W7500x Errata Sheet

Document History

Ver 1.0.0 (July.11, 2016)	First release (erratum 1) - I2C
Ver 1.0.1 (Dec.08, 2016)	Correct SCL speed
Ver 1.1.0 (Jun.18, 2018)	erratum 2 - Transmission Delay
Ver 1.2.0 (May.12. 2019)	Erratum 3 - IAP Function Call Failure Erratum 4 - Two Image Banks Failure Erratum 5 - Cold Booting Failure

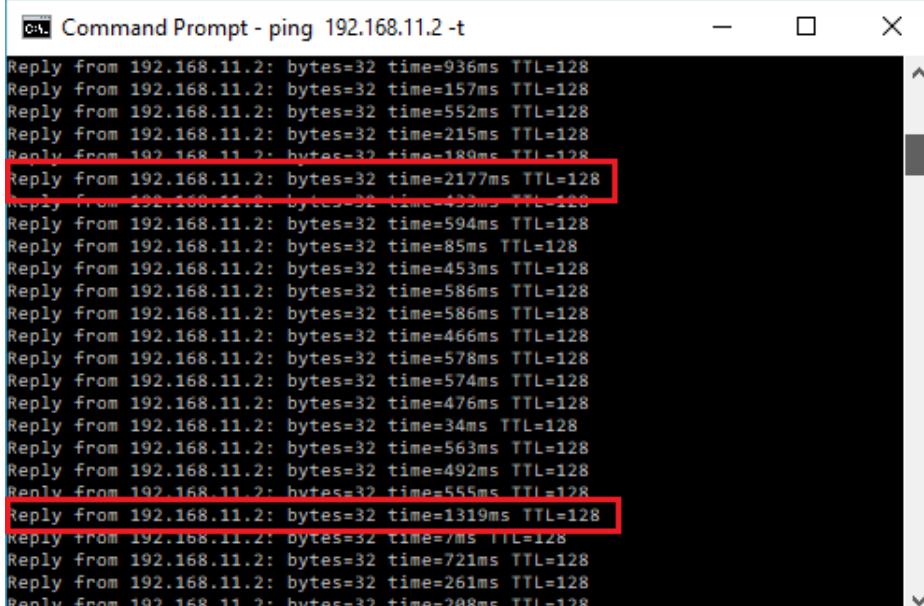
Erratum 1	
Phenomenon	Receiving repeating data in continuative data transmission causes I2C communication problem.
Condition	 <p>W7500 receives the first repeating data but starts to discards from the 2nd repeating data to next different data in continuative data transmission. It causes data loss.</p>
Solution & Recommendation	<p>To avoid this issue, W7500 uses GPIO instead of I2C. In this case, SCL has limited speed, 100KHz.</p> <p>Example pseudo code:</p> <pre> Function Initialize_I2C () { ... scl_port_num = I2C_PORT(conf->scl); scl_pin_index = I2C_PIN_INDEX(conf->scl); sda_port_num = I2C_PORT(conf->sda); sda_pin_index = I2C_PIN_INDEX(conf->sda); //SCL setting GPIO_InitDef.GPIO_Pin = scl_pin_index; GPIO_InitDef.GPIO_Mode = GPIO_Mode_OUT; if(scl_port_num == 0) { GPIO_Init(GPIOA, &GPIO_InitDef); GPIO_SetBits(GPIOA, scl_pin_index); } ... //SDA setting </pre>

/* START function */

Function I2C_START

void I2C_Start(I2C_ConfigStruct* conf)
{
    I2C_WriteBitSCL(conf, 1);
    I2C_WriteBitSDA(conf, 1);

I2C_WriteBitSDA(conf, 0);
    I2C_WriteBitSCL(conf, 0);
}

/* STOP function */

Function I2C_STOP

void I2C_Stop(I2C_ConfigStruct* conf)
{
    I2C_WriteBitSCL(conf, 0);
    I2C_WriteBitSDA(conf, 0);

I2C_WriteBitSCL(conf, 1);
    I2C_WriteBitSDA(conf, 1);
}

Erratum 4
Two Image Banks Issue

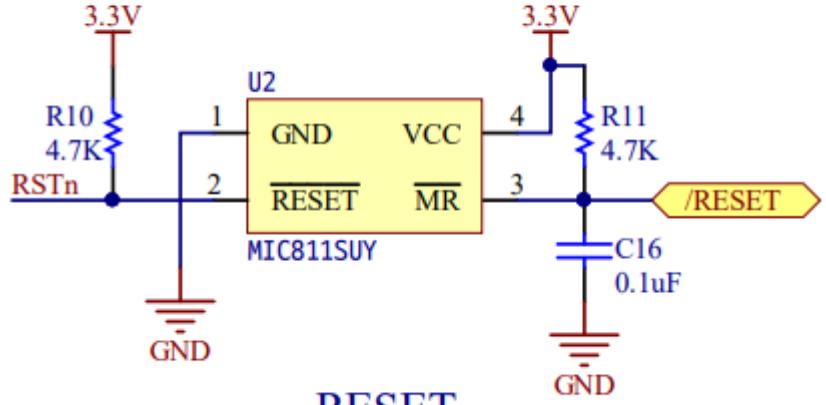
Phenomenon	The processor hangs during Bank 2 operation if the internal flash memory is divided into dual banks to implement functions such as firmware update.
Condition	This problem occurs because W7500x does not support 'interrupt vector table remaps'. If internal flash memory is divided and used as a dual bank, Bank 1 application starting from address 0 operates without problems. However, if an interrupt occurs while the Bank 2 application is operating, a process stuck occurs because the interrupt vector table at address 0 is referenced.
Solution & Recommendation	<p>A user can avoid the problem by copying the interrupt vector table in the bank 2 area to address 0 if the user utilizes the Bank 1 as the boot area and Bank 2 as the application area.</p> <p>The following conditions must be met:</p> <ol style="list-style-type: none"> 1. In the case of most functions operate on bank 2 and bank 1 only uses internal flash update 2. All interrupts must be disabled in bank 1 code 3. The solution of Erratum 3 must be guaranteed since the IAP operation is performed when copying the interrupt vector table. <p>Following is an example.</p> <pre> void Copy_Interrupt_VectorTable(uint32_t start_addr) { uint32_t i; uint8_t flash_vector_area[SECT_SIZE]; for (i = 0x00; i < 0x08; i++) { flash_vector_area[i] = *(volatile uint8_t *) (0x00000000+i); } for (i = 0x08; i < 0xA8; i++) { /* Actual address range; Interrupt vector table is located here */ } } </pre>

/* Erase the interrupt vector table area : Sector 0 */
DO_IAP(IAP_ERAS_SECT, 0x00000000, 0, 0);

/* Write the application vector table to 0x00000000 */
DO_IAP(IAP_PROG, 0x00000000, flash_vector_area , SECT_SIZE);

/* Global interrupt enabled */
_enable_irq();
}
```
